TITLE: FUSELAGE - CENTER FUSELAGE - REINFORCE UPPER FRAME FEET FITTINGS.

This page transmits Revision No.04 of Service Bulletin No.A300-53-6125

SERVICE BULLETIN No.: A300-53-6125

REVISION No.: 04 - Mar 17/15

Figure A-FCAAA - Sheet 02
Repair of the Hole H1 on FR41 thru FR46

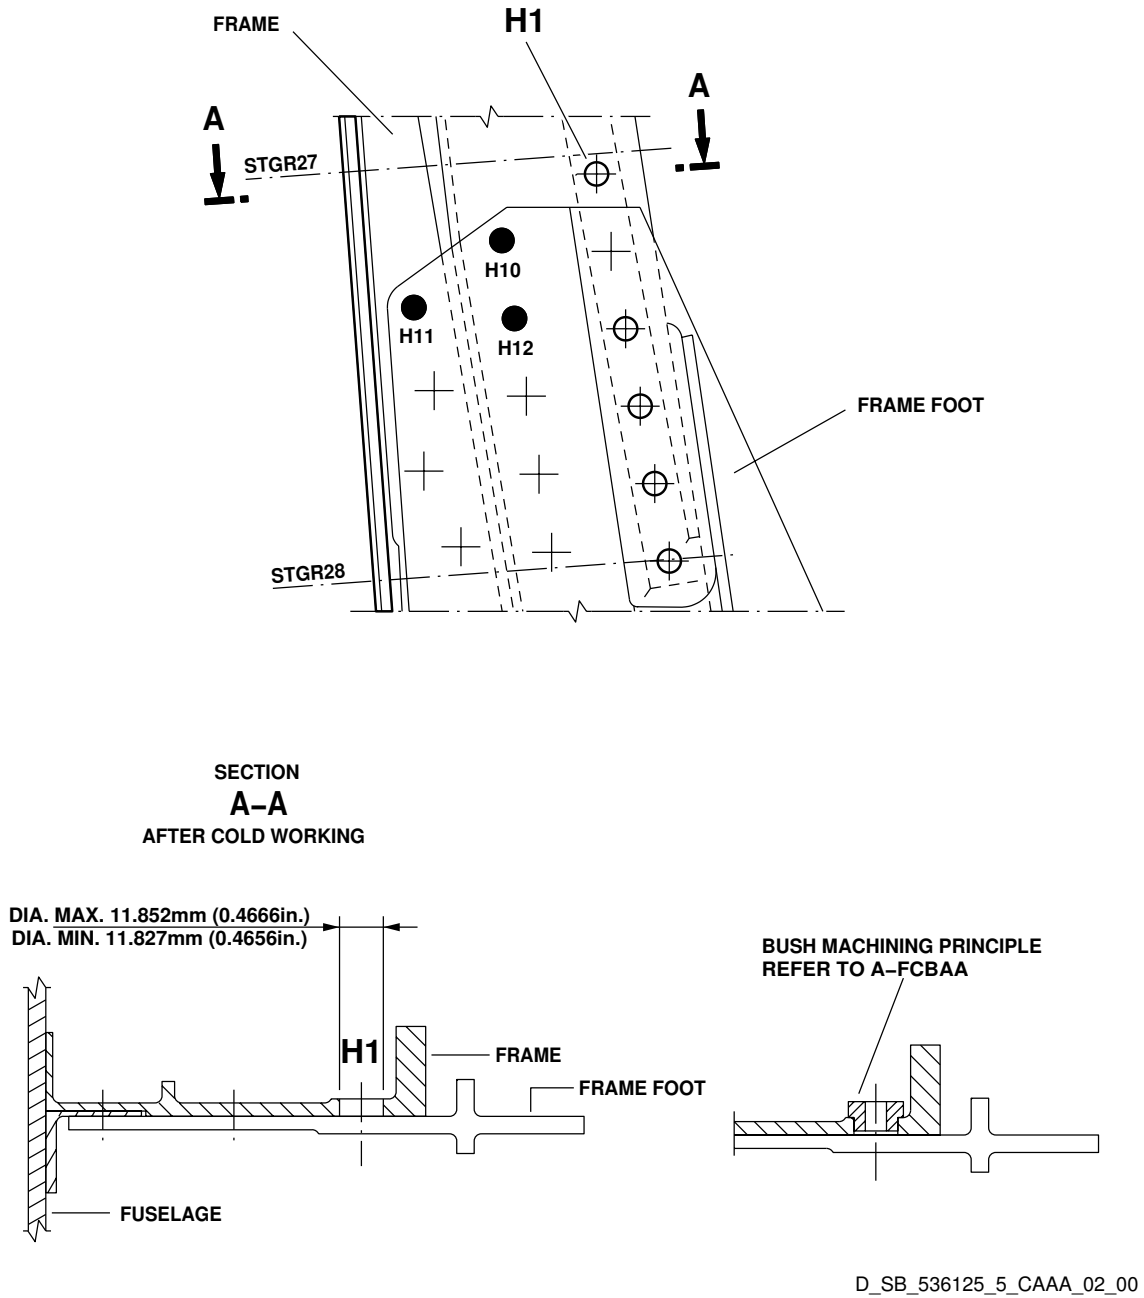
- (a) Remove the fasteners and the bush for the hole H1, refer to the table given in the [Fig. A-FCAAA Sheet 03](#).
- (b) Cut out the frame foot in relation with the dimensions given in the [Fig. A-FCAAA Sheet 01](#).

- (d) Ream the hole H1 to the initial hole diameter, then do the cold expansion operation and ream to the final diameter, refer to the table given in [Fig. A-FCAAA Sheet 03](#).

Refer to [Fig. A-FCAAA Sheet 02](#), [Fig. A-FCAAA Sheet 03](#)

Figure A-FCBAA - Sheet 01
Principle of Bush Manufacturing

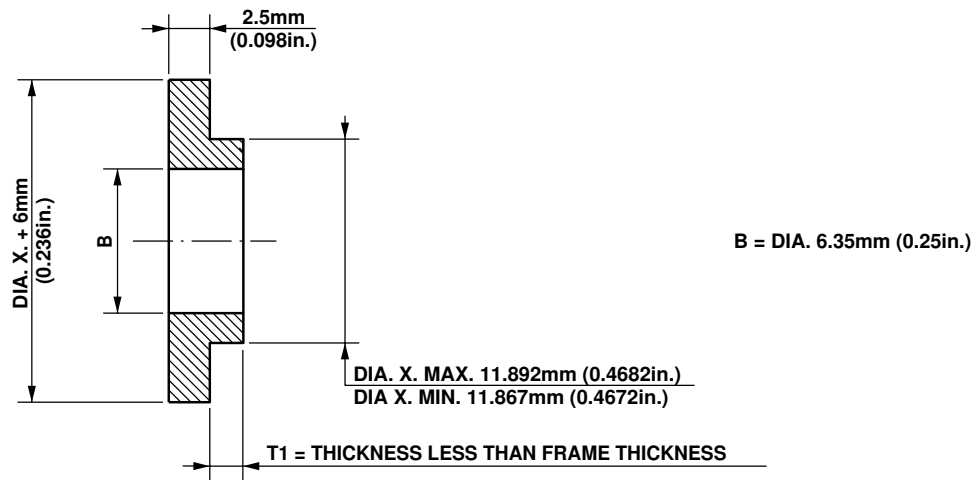
- (e) Install a shouldered bush on the frame in accordance with the dimensions given in the [Fig. A-FCBAA Sheet 01](#).
